PRODUCT / PROCESS CHANGE INFORMATION

1.1 Company	 STMicroelectronics International N.V
1.2 PCI No.	MDG/23/14015
1.3 Title of PCI	AMKOR (Taiwan) STM32F412RxY6TR WLSCP package pin1 orientation in carrier tape harmonization
1.4 Product Category	STM32F412RGY6TR STM32F412REY6TR
1.5 Issue date	2023-04-26

PCI 14015 AMKOR (Taiwan) STM32F412RxY6TR WLSCP package pin1 orientation in carrier tape harmonization

Qualification Report

AMKOR WLCSP Package mis-orientation of Pin1 in carrier tape

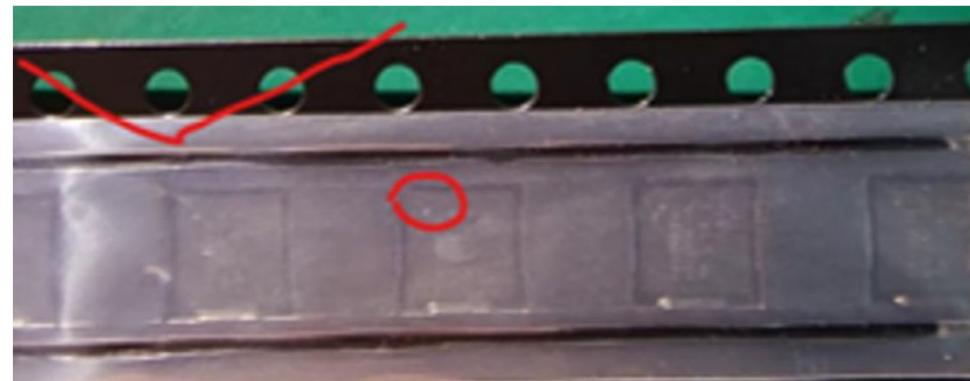
- Before

- After

Risk assessment and conclusion

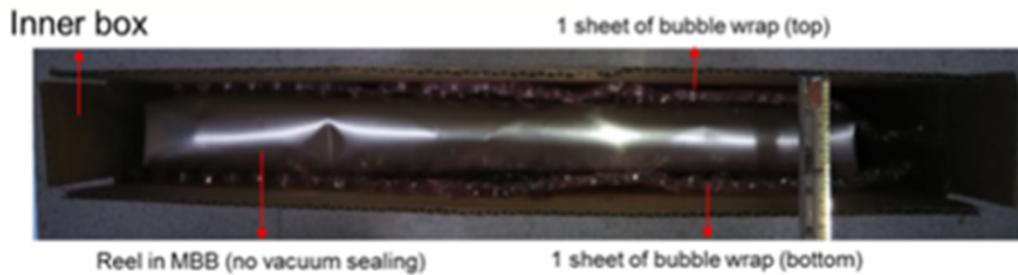
- Carrier Tape fit analysis on orientation top left
 - Risk assessment done
 - Minimum (50 um) and Maximum clearance meet with pin1 top left
 - Note that clearance are meet also with pin1 top right.
 - No risk to produce on any of both orientation.
- Conclusion : No concern on the Fit Analysis between pocket size (Ao, Bo, Ko) & die size (X,Y,Z).
